TORQ-MATIC WRENCH  
PRODUCT BULLETINS

<b>Product Bulletin #</b>	<b>Subject</b>	<b>Page</b>
Wrench 001	Leaking Fittings within the hydraulic valve Banks	5
Wrench 002	Cylinder Gusset Failure on Main Boom	6
Wrench 003	Orientation of spinner roller seals	7
Wrench 004	Shearing Belleville Stack Mounting Studs	10
Wrench 005	Inspection of Main Boom Pin Tube and Support Gussets	15
Wrench 006	High Pressure Control Seats for Hydraulic Valve	24
Wrench 007	Inspection of Vertical Lift Channel	27
Wrench 008	Tong Cylinder Orifice	27
Wrench 009	37-Pin Cable and Receptacle Cap Plugs Getting Pinched	30
Wrench 010	Cable Guide / Encoder Guard	33
Wrench 011	Locking Joystick on Driller's Console	37
Wrench 012	Sealed Electric Operator for Horizontal Extend/Retract Valve	42
Wrench 013	Tong Cyliner Upgrade	56
Wrench 014	Wrench Lifting Procedure	61

SHEET 1 OF 1 AY50927 REV A

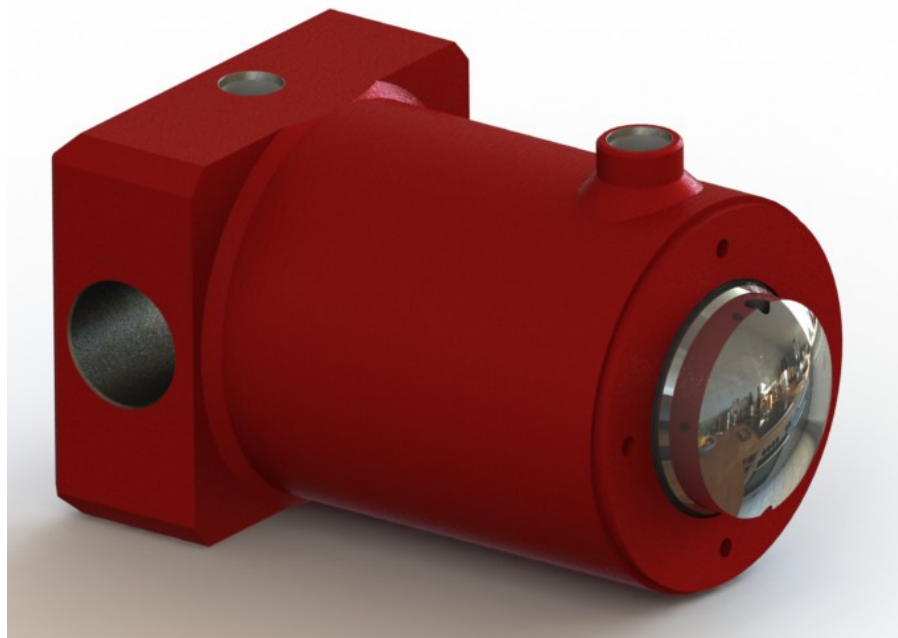
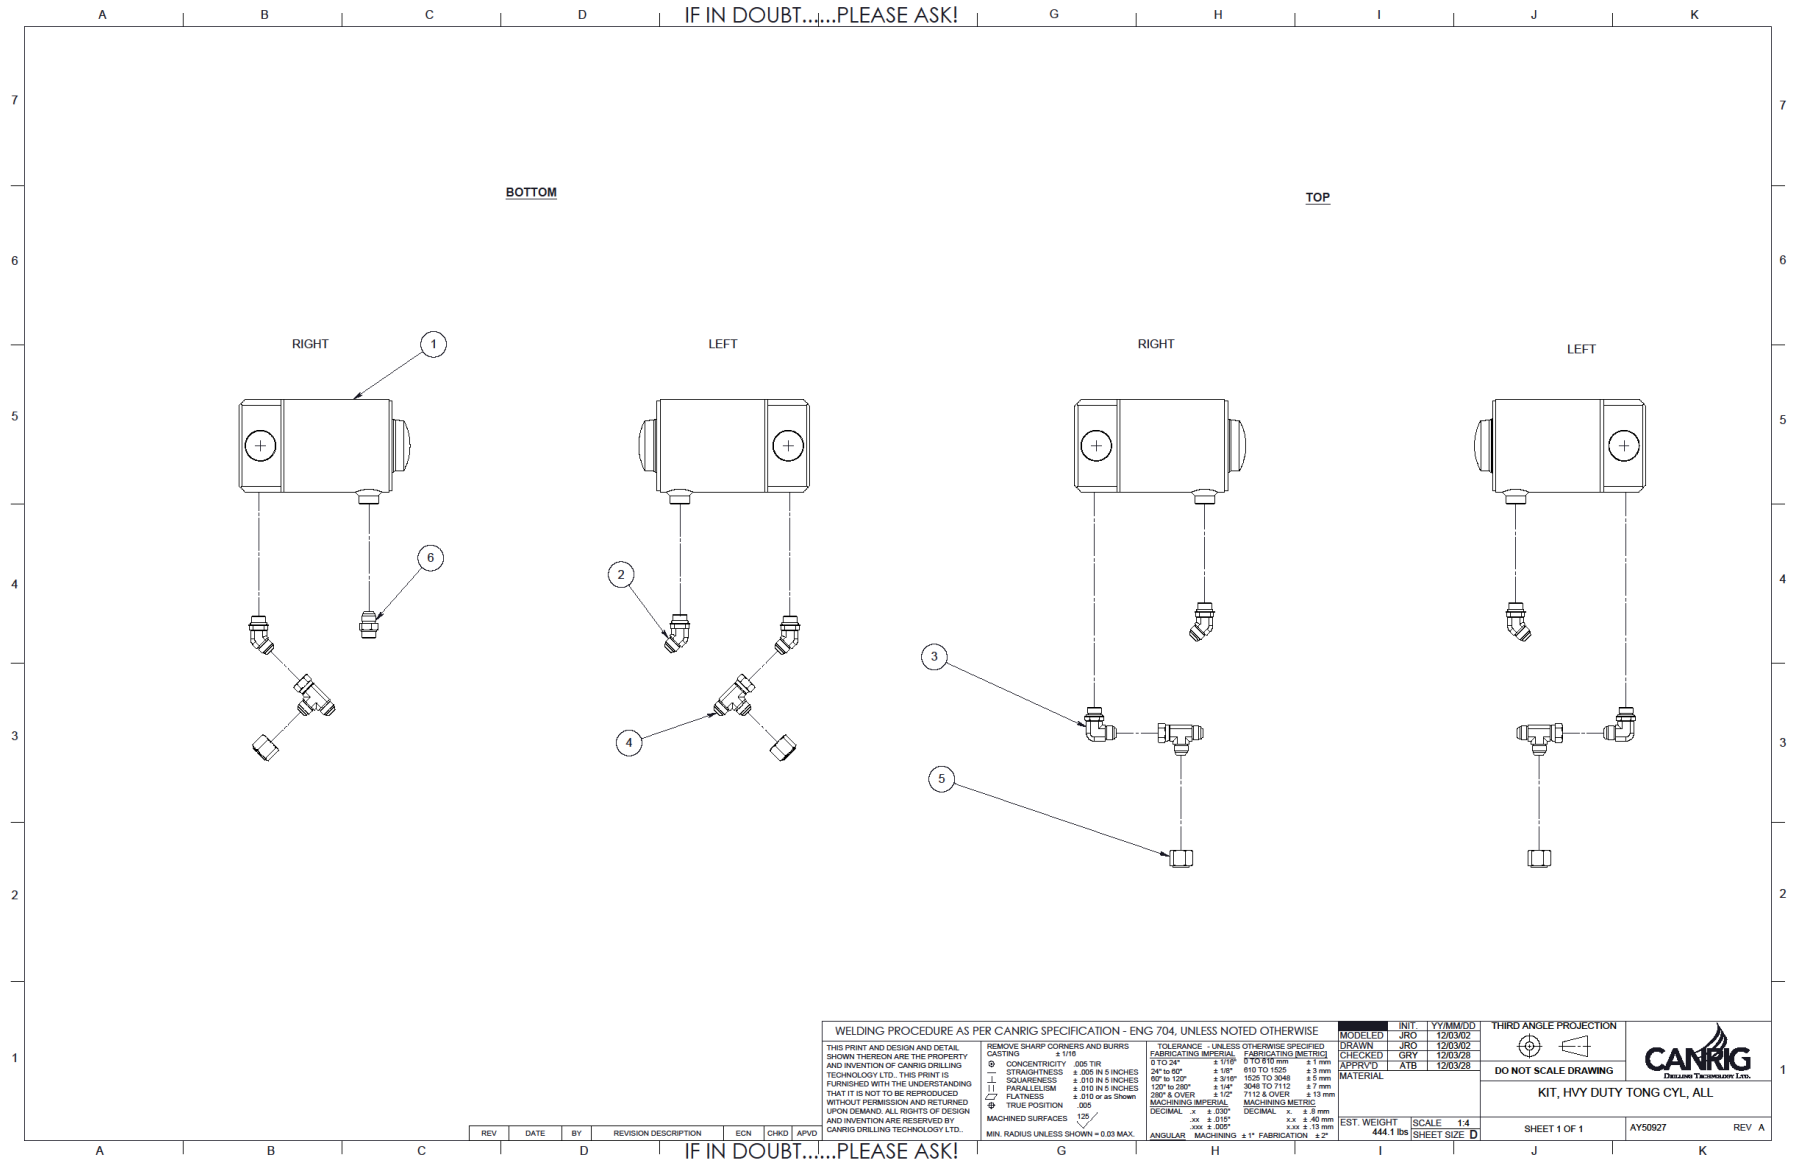
**DISCUSSION:** Heavier duty tong cylinders are now available as an upgrade to the existing upper & lower, left & right tong cylinders used on the TM-80.

When ordering a complete set of four replacement cylinders, use part number AY50927 (drawing attached). This kit includes the cylinders and a complete set of adapter fittings.
